DM/24/2922 Hollyrood House, Ardingly Road, Lindfield, West Sussex RH16 2RA

HOLLYROOD HOUSE, ARDINGLY ROAD, LINDFIELD

Site Accesses and Bus Stop Improvements

Stage 1 Road Safety Audit

Date JAN 2024	Scale 1:500	Size A1
Drawing No. 24044-001		Rev B

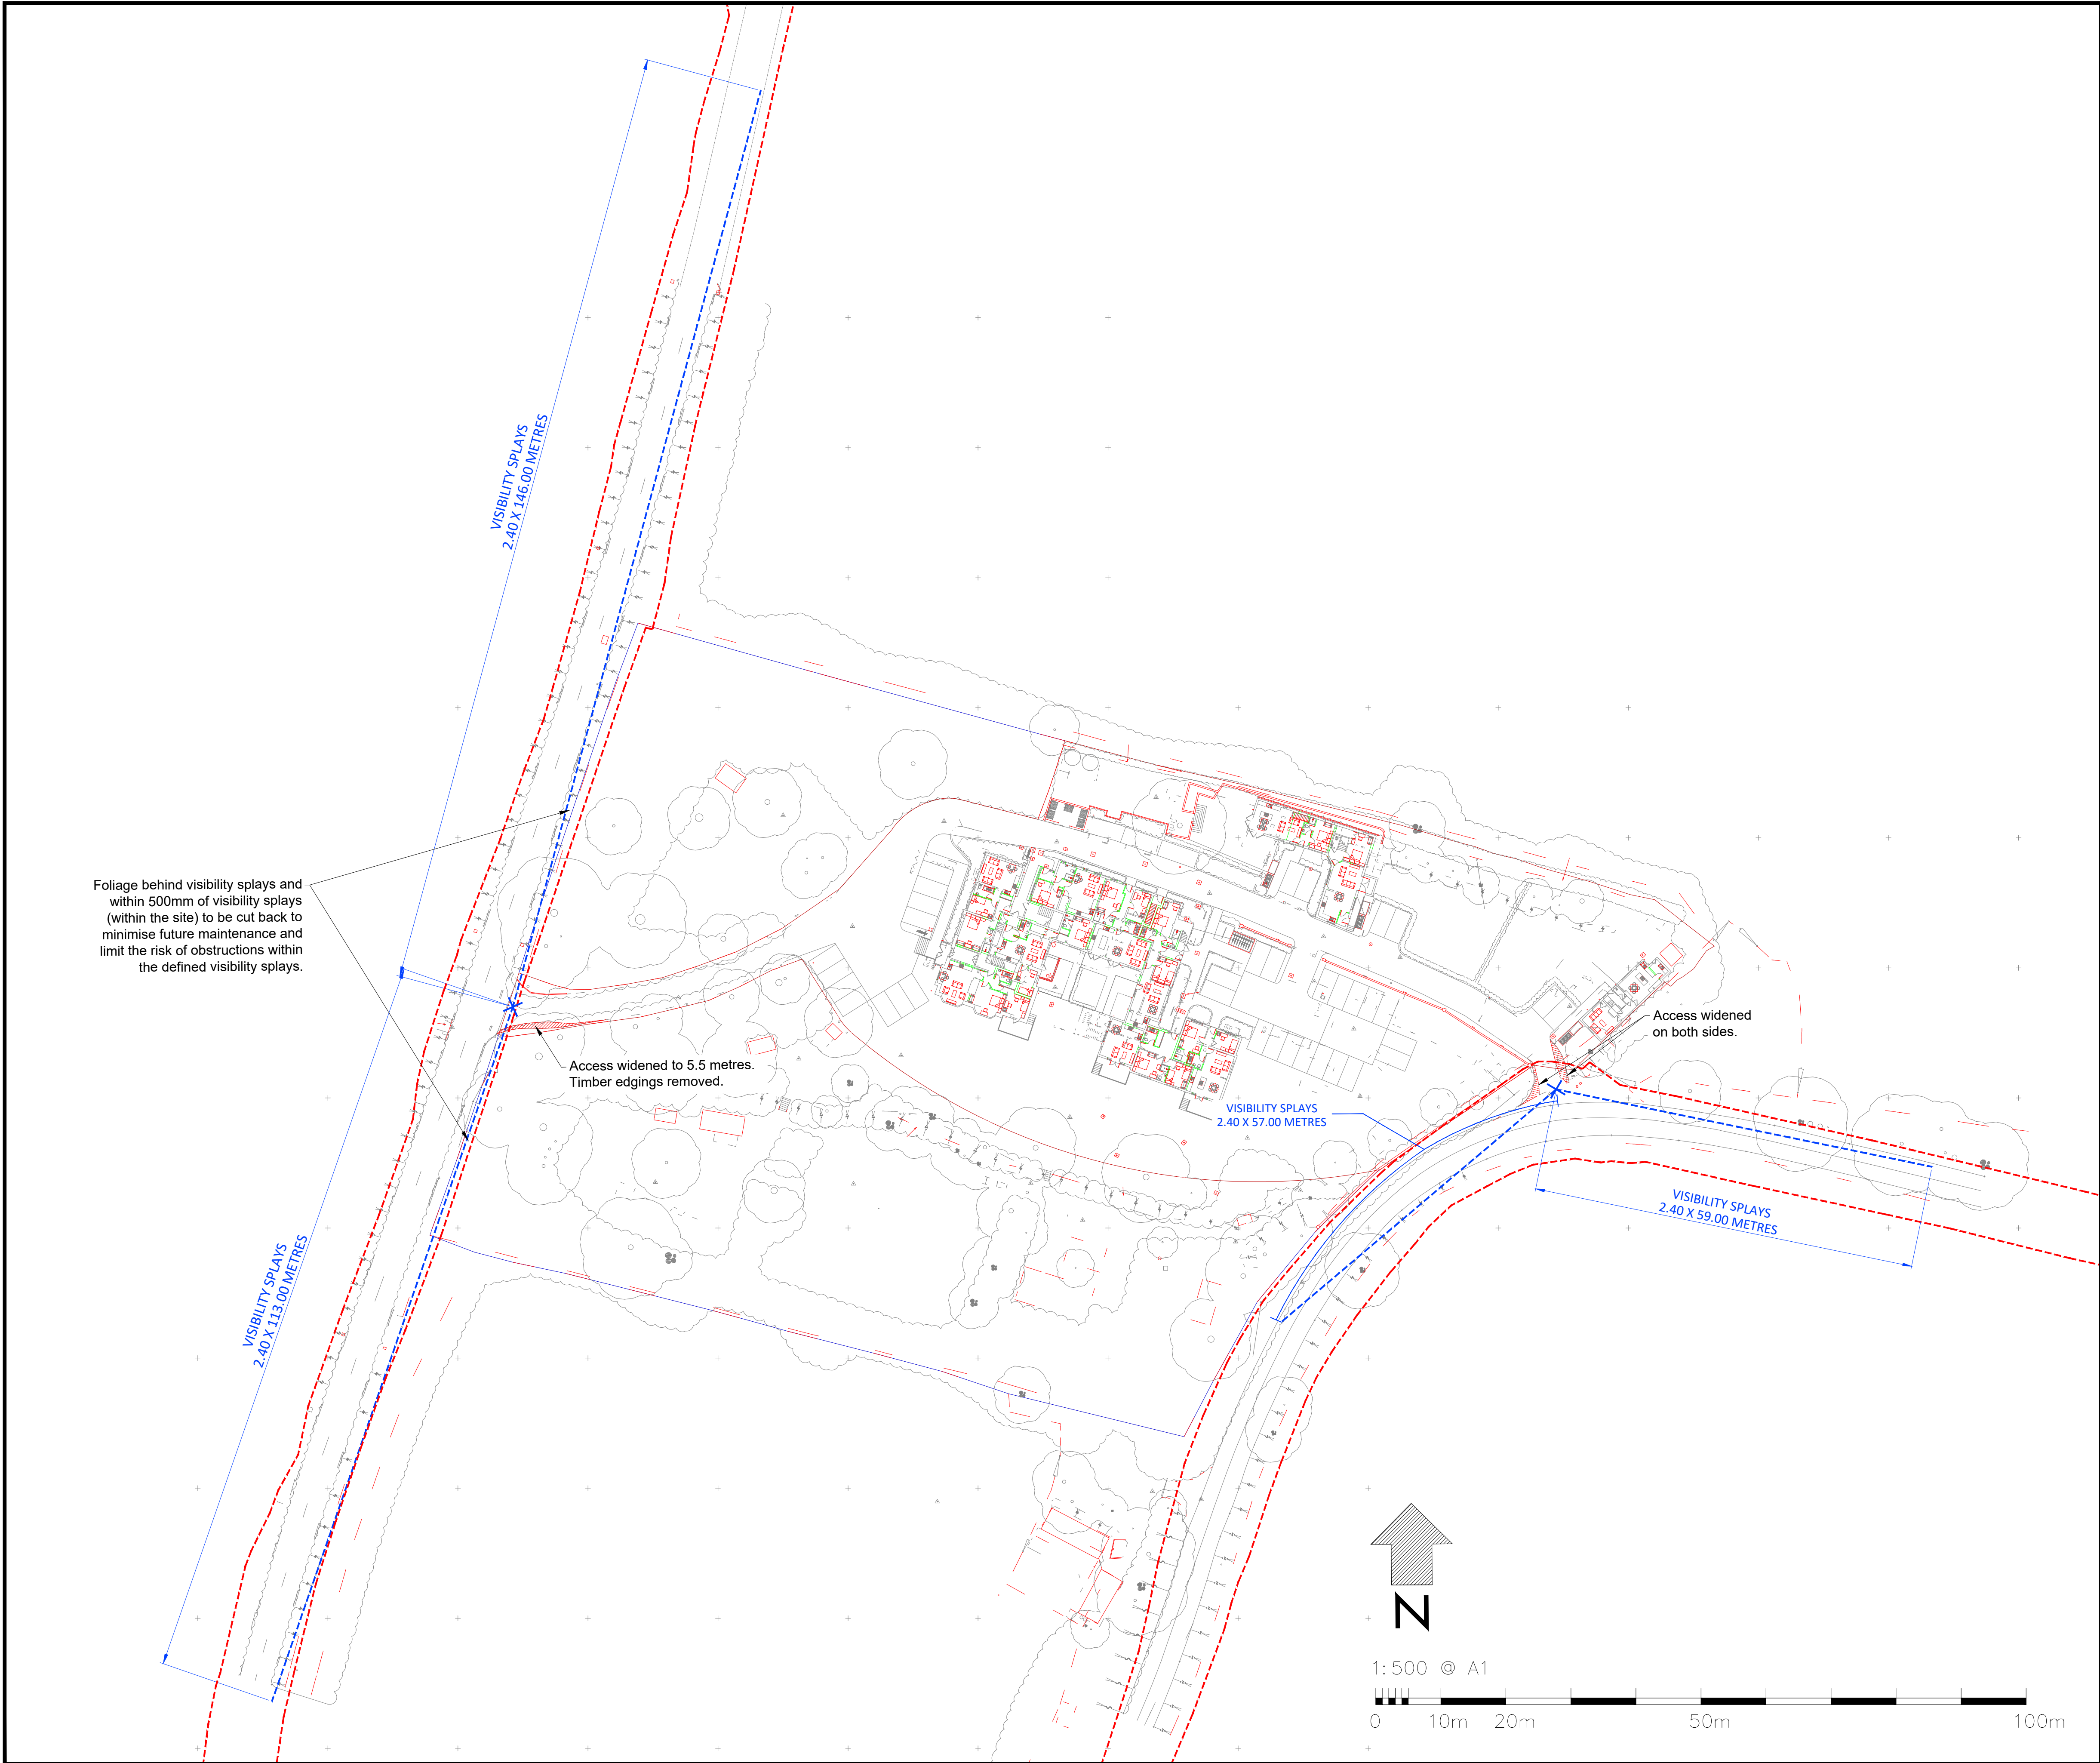
2.3 Problem

Potential vehicle collisions due to foliage/boundary treatments obscuring junction visibility.

Location: Both sides of Ardingly Road access junction

It is not clear to what extent foliage will be removed to provide the junction visibility splays. It could in future grow back and obstruct visibility from the site access along Ardingly Road, which could lead to vehicle turning collisions.

Recommendation

Cut back foliage with sufficient clearance behind the junction visibility splays to minimise future maintenance and limit the risk of obstruction to the emerging driver's view.

RSA Decision Log				
Item No.	RSA Recommendation	Design Organisation Response	Overseeing Organisation Comments	Agreed RSA Action
2.3	Cut back foliage with sufficient clearance behind the junction visibility splays to minimise future maintenance and limit the risk of obstruction to the emerging driver's view.	Recommendation accepted. Drawing 24044-001 (visibility splays) amended to include reference to foliage behind visibility splays (within 500mm and within the site) to be cut back to minimise future maintenance and limit the risk of obstructions to visibility.

Foliage behind visibility splays and within 500mm of visibility splays (within the site) to be cut back to minimise future maintenance and limit the risk of obstructions within the defined visibility splays.
